Application Number: SSI 7485

WestConnex M4-M5 Link

I submit my objection to the WestConnex M4-M5 Link proposals for the reasons stated below, and request the Minister reject the application entirely, and cause the proponents to reissue an EIS that is based on a fully researched, developed, and budgeted concept design, and require the proponents to prepare a new business case against that design.

The EIS states in 6.5.8 Darley Road civil and tunnel site (C4) that:

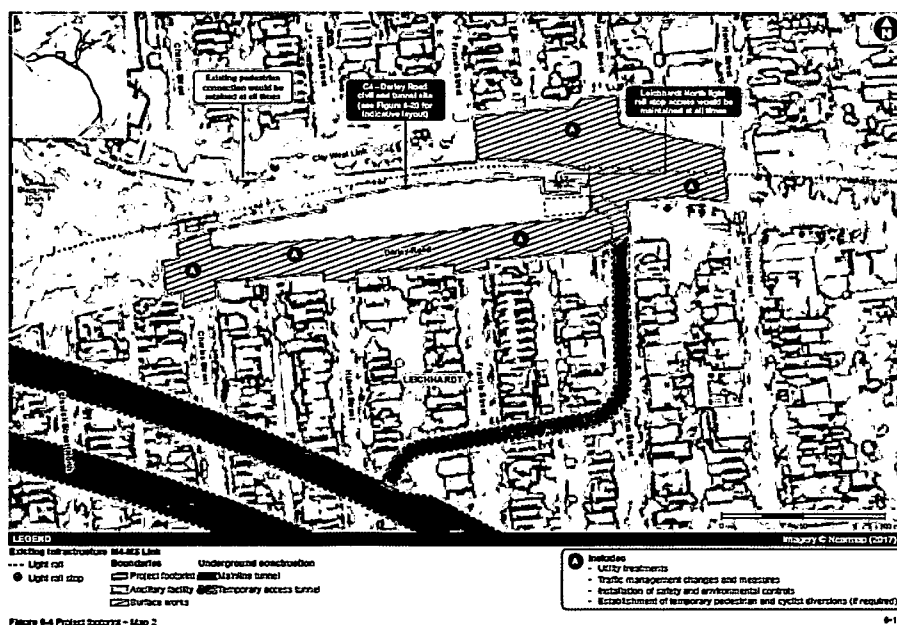
1. I object to the EIS because it fails to describe the temporary changes to Darley Road, Leichhardt to enable access to and from the ancillary facility that would likely be required in relation to the Darley Rd site and instead allows for the final plan to be decided by the contractor.

It is not clear how continued access, pedestrian and cyclist movement will be preserved and I am concerned that the impacts have not been correctly identified and assessed by the proponent.

Cumulative impacts of aircraft noise and construction noise

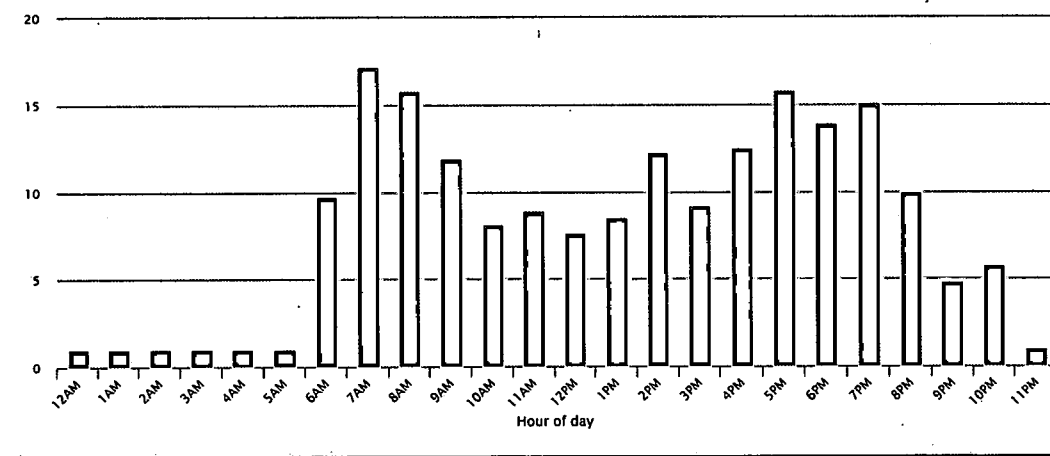
- I object to the EIS because the proponent has failed to take account of the cumulative impact of its proposed Darley Road, Leichhardt civil and tunnel site operations and the aircraft noise which the residents near the site already endure.

The attached extract from Webtrak shows that Darley Road, Leichhardt and adjacent streets are directly under the flight path.
